CITY OF WICHITA, KANSAS
MICHAEL E. LINDEBAK, P.E., CITY ENGINEER
STORM WATER IMPROVEMENTS
IN
ROCKWOOD CENTER 2ND ADDITION
CITY OF WICHITA PRIVATE PROJECT NO. 1083PPS(6Q7861)

APPROVED AS NOTED
BY CITY ENGINEER OF WICHITA

SANITARY SEWERS ______
STORM SEWERS VRH 1/17/01
DRIVEWAY APPROACHES ______
WATER MAINS ______
PAVING ______

UTILITY & SITE PLAN

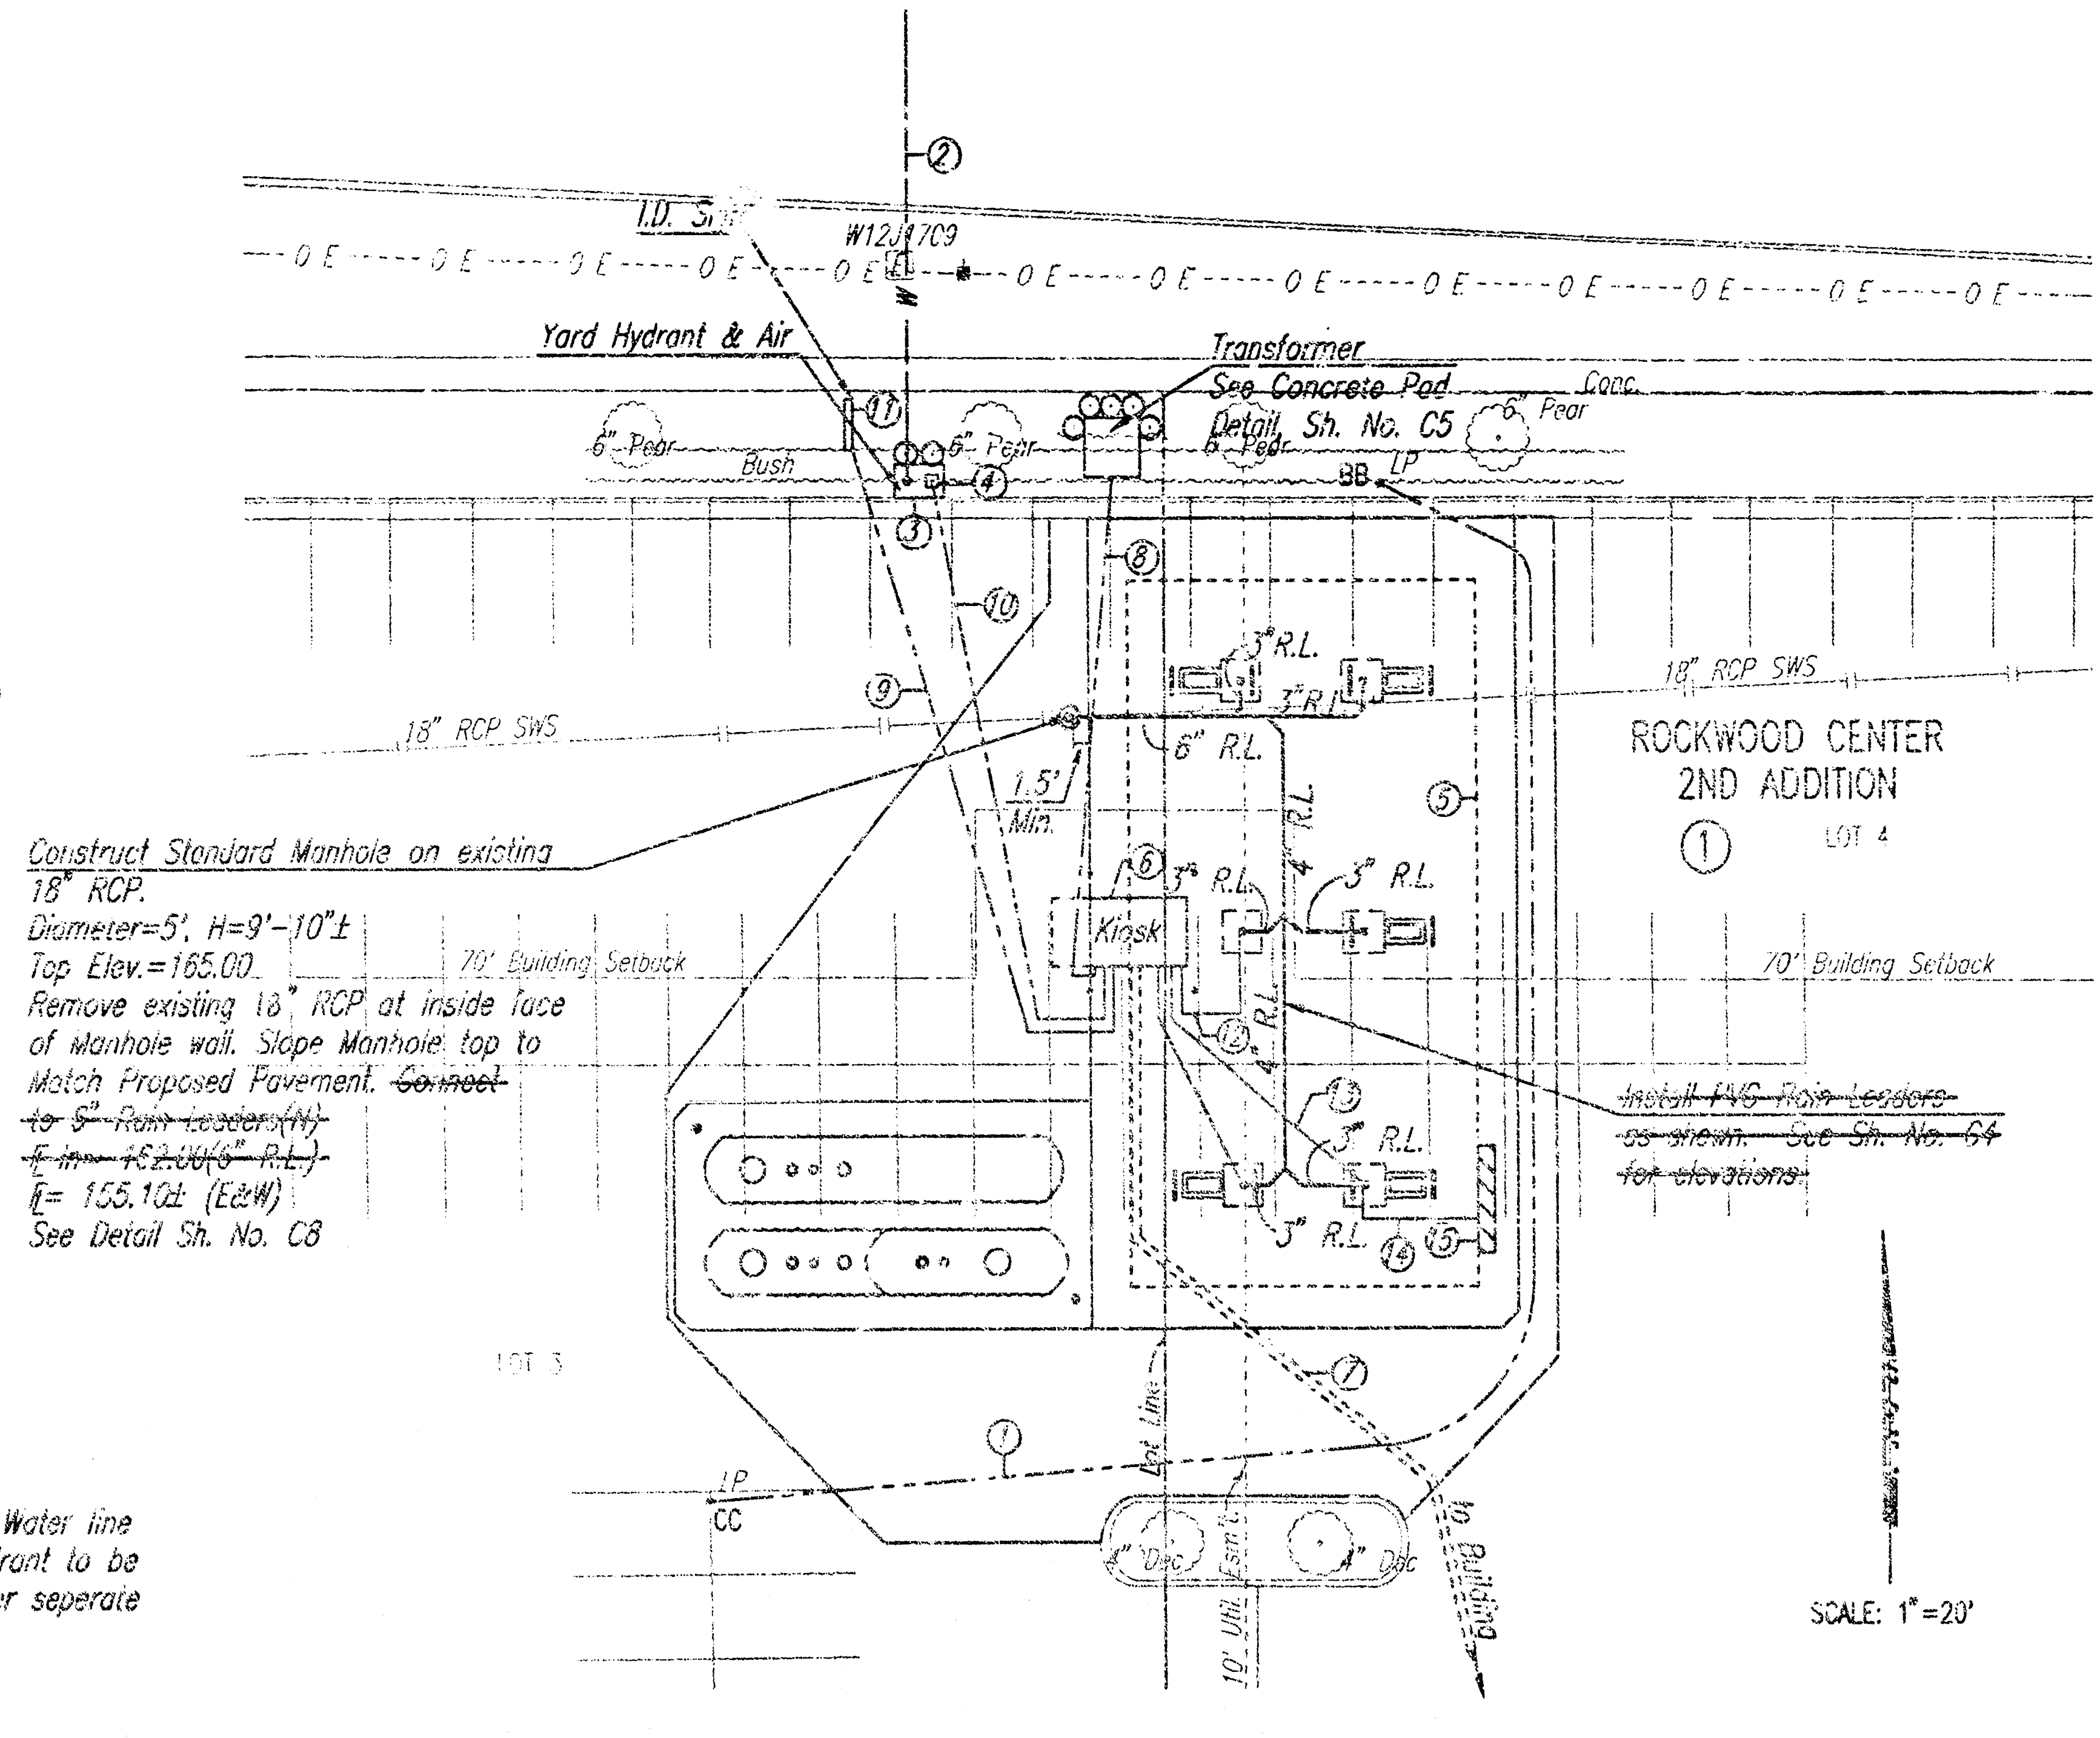
Construct Standard Manhole on existing 18" RCP.
Diameter=5', H=9'-10"±
Top Elev.=165.00
Remove existing 18" RCP at inside face of Manhole wall. Slope Manhole top to Match Proposed Pavement. ~~Connect to 6" Rain Leaders(N)~~
~~ℓ in= 152.00(6" R.L.)~~
ℓ= 155.10± (E&W)
See Detail Sh. No. C8

~~Install PVC Rain Leaders as shown. See Sh. No. C4 for elevations.~~
